**Consolidated Proposals to  
Amend the Draft Text of the  
FRAV Interim Submission to WP.29**

*This table covers FRAV discussions up to and including the 39<sup>th</sup> session. Unshaded table cells have not yet been reviewed in session by FRAV.*

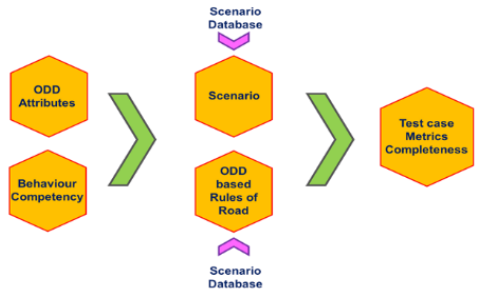
4.2.1.	A knowledge-driven scenario generation approach utilizes domain specific (or expert) knowledge to identify hazardous events systematically and create scenarios. A data driven approach utilizes the available data (e.g. accident databases, insurance records) to identify and classify occurring scenarios. [Figure x] illustrates various data-based and knowledge-based scenario generation methods.		Consider sections to differentiate and address knowledge-based and data-based scenario development? The text mixes the two approaches and appears to direct the reader to the “rules of the road” annex for knowledge-based scenario generation and to the “safety models” annex for data-based scenario generation.
Figure 1.			Refer to FRAV-31-19 for original figure.
